## Firefly Terminator G4 Tap Connector

<b>Bulletin Type:</b>	TSB	<b>Publication Date:</b>	September 2022
<b>Bulletin #(s):</b>	22-076	<b>Make(s):</b>	Jayco & Entegra Coach
<b>Job Code(s):</b>	9803580	<b>Model(s):</b>	Ethos LI (20AL, 20TL) Launch (19Y) Launch LE (19Y) Swift LI (20AL, 20TL) Terrain (19Y) Terrain LE (19L)
<b>Flat Rate(s):</b>	9803580 - .10 Repair	<b>Model Year(s):</b>	2022

<b>Incident:</b>	Communication error within the lithium battery
<b>Affected Units:</b>	Certain Jayco 2022 Swift LI, Terrain, Terrain LE & Certain 2022 Entegra Coach Ethos LI, Launch, Launch LE
<b>Parts Kit: 22-076JM</b>	Parts Kit #: 22-076JM 1 - CONNECTOR,G4 TERM DRP TAP (Jayco Part #0209671)
<b>Misc. Tools &amp; Supplies:</b>	N/A
<b>Parts Return Information:</b>	N/A

Fig. 4

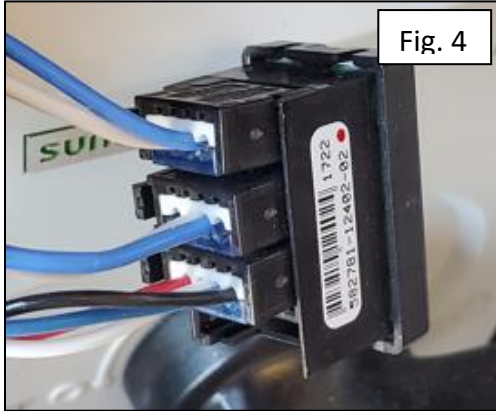
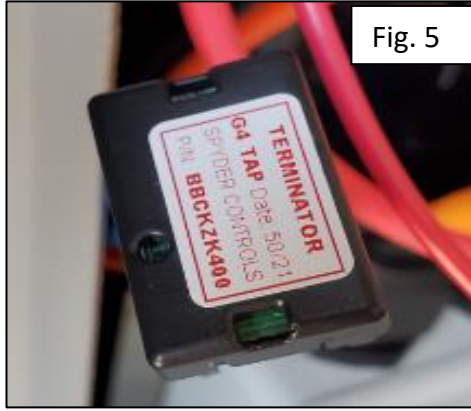
2. Remove the three plugs from the Common G4 Tap (Figure 4) and place them into the new Terminator G4 Tap from the parts list. (Figure 5)
  - A. **NOTE:** With the Terminator G4 Tap installed, ensure that the Firefly and Renogy Battery screens are providing accurate information and/or are not showing faults.
